**PLANNING APPROVAL STAFF REPORT****Date: January 7, 2016****NAME**

Union Missionary Baptist Church

**CONTEMPLATED USE**Planning Approval to allow the expansion of an existing  
church in an R-2, Two-Family Residence District.**TIME SCHEDULE  
FOR DEVELOPMENT**

# SITE PLAN

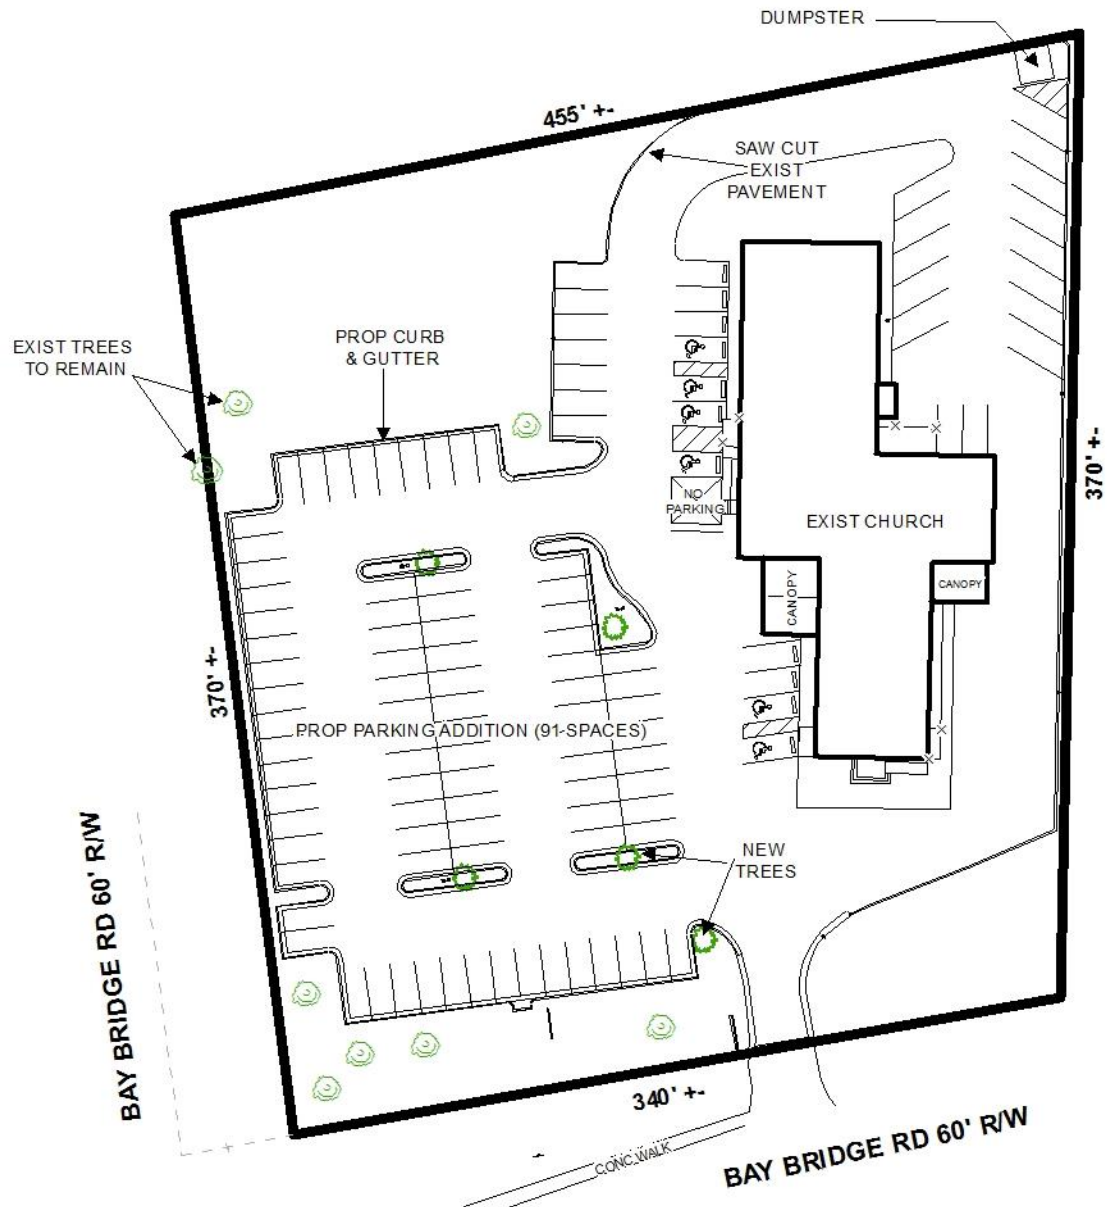
The site plan illustrates an existing building and 120 proposed parking spaces with asphalt surfacing. The proposed parking lot exceeds the minimum off-street parking requirements regarding number of parking spaces, which are based upon the amount of seats within a church sanctuary.

Six required parking spaces are designated as handicap accessible, and a van accessible space is provided, each of which meet the minimum Zoning Ordinance requirements for stall and access aisle length and width, and satisfy the minimum requirements for handicap parking.

It should also be noted that 16 of the proposed parking spaces, each of which abut proposed curbing within corner sections of the lot and at the ends of central parking sections, do not meet stall width requirements. If approved, revisions to the site plan will be required to illustrate compliance with Section 64-6.A.2. of the Zoning Ordinance regarding minimum parking stall dimensions.

Regarding minimum parking aisle dimensions, the site plan illustrates that a majority of aisle widths are 24', thus indicating a two-aisle configuration to accommodate two-way traffic; however, those aisles proximal to tapered curbs that delineate parking lot sections do not meet the minimum 24' width requirements for two-way traffic. Additionally, parking stalls illustrated with a 20' stall length and 10.5' stall width are configured in such a way that limit aisle width to 21', thus suggesting a one-way aisle configuration for one-way traffic; however, the site plan does not illustrate how one-way traffic circulation will be implemented. If approved, revisions to the site plan will be required to illustrate two-way aisle configurations 24' wide, exclusive of curb tapers, and to illustrate one-way traffic circulation either in the form of signage, painted arrows, or another approved method.

Due to the amount of site improvements, if approved, a photometric plan for the entire lot is required and should illustrate compliance with Section 64-6.A.8. of the Zoning Ordinance regarding new parking lot lighting.

The site plan does not meet minimum landscaping and tree requirements regarding the amount of required frontage, perimeter, and parking lot trees. If the current application is approved, per previous Planning Approval, revisions to the site plan illustrating full compliance with section 64-4.E. of the Zoning Ordinance will be required.

An existing dumpster is illustrated on the site plan but it is unclear whether or not it meets the current enclosure and sanitary sewer connection requirements of Section 64-4.D.9. of the Zoning Ordinance. If approved, revisions to the site plan illustrating compliance with dumpster regulations will be required as 2014 aerial photos imply that the existing dumpster will be relocated, per the submitted site plan.

Because the site is commercially utilized and abuts R-2, Two-Family Residence Districts to the North, East and West, a protection buffer is required per Chapter 64-4. D.1. of the Zoning

Ordinance; the site plan does not illustrate such a buffer. Therefore, if approved, an appropriate protection buffer in the form of a wall, wooden privacy fence, or the inclusion of a screen planting strip is recommended to ensure compliance with the aforementioned protection buffer requirements of the Zoning Ordinance, and should be illustrated on a revised site plan.

- 1) revision of the site plan to illustrate compliance with Section 64-6.A.2. regarding minimum parking stall dimensions;
- 2) revision of the site plan to illustrate compliance with Section 64-6.A.2. regarding minimum two-way aisle dimensions, exclusive of any curb tapers;
- 3) provision of a photometric plan illustrating full compliance with Section 64-6.A.8. of the Zoning Ordinance at time of permitting;
- 4) revision of the site plan to illustrate full compliance with Section 64-4.E. regarding minimum tree and landscaping requirements;
- 5) revision of the site plan to illustrate compliance with Section 64-4.D.9. regarding current dumpster requirements; and
- 6) revision of the site plan to illustrate compliance with Section 64-6.D.1. regarding protection buffer requirements.
